# Access Compliance Report

## Public Rights-of-Way

### (Curb Ramps)

Intersection ID: 29389	Main Street: GOLD_PAN_RD	Cross Street: REEDY_PLANTATION_RD	Location: SE
ADA ID: EE92BE5A7666	Ramp Type: PerpDiag	Initial Pass/Fail: Fail	Overall Compliance: No
Severity Score: 22.5			
Codes/Mitigation Info/Possible Solution		Field Measurements/Component Compliance

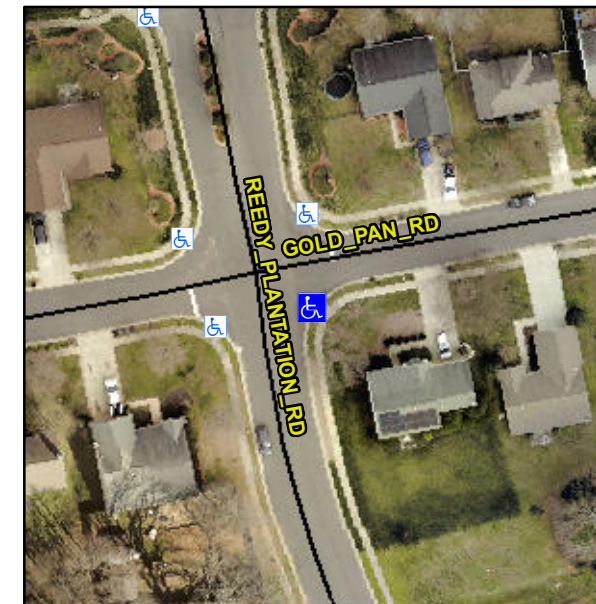
**Not Found, R304.5.1, R304.2.2, R304.5.3**

Compliance	Description	Data	Compliance	Description	Data
N/A	Ramp Length (in)	48.5	No	Ramp Slope (%)	9.2
No	Ramp Width (in)	47.5	No	Ramp XSlope (%)	4.9
N/A	Flare Type LT	N/A	N/A	Flare Type RT	N/A
N/A	Flare Slope LT (%)	N/A	N/A	Flare Slope RT (%)	N/A
N/A	Flare Traversable LT?	N/A	N/A	Flare Traversable RT?	N/A
N/A	Landing Length (in)	N/A	N/A	DWS Provided?	N/A
N/A	Landing Width (in)	N/A	N/A	DWS Contrast?	N/A
N/A	Landing Slope (%)	N/A	N/A	DWS Length (in)	N/A
N/A	Landing X Slope (%)	N/A	N/A	DWS Full Width?	N/A
N/A	Landing Curb? (Y/N)	N/A	N/A	DWS Offset (in)	N/A
N/A	Shared Landing?	N/A			
N/A	Gutter Ponding?	N/A	N/A	Gutter Slope (%)	N/A
N/A	Gutter Lip Ht (in)	N/A	N/A	Gutter X Slope (%)	N/A
N/A	Painted X Walk1?	No	N/A	Painted X Walk2?	No
	X Walk 1 Direction	To N		X Walk 2 Direction	To W
N/A	X Walk 1 Width (in)	N/A	N/A	X Walk 2 Width (in)	N/A
	X Walk 1 Slope (%)	0.4		X Walk 2 Slope (%)	5.5
	X Walk 1 X Slope (%)	4.0		X Walk 2 X Slope (%)	3.1

**Remove & Replace Curb Ramp With Two New Directional Ramps or Equivalent.**
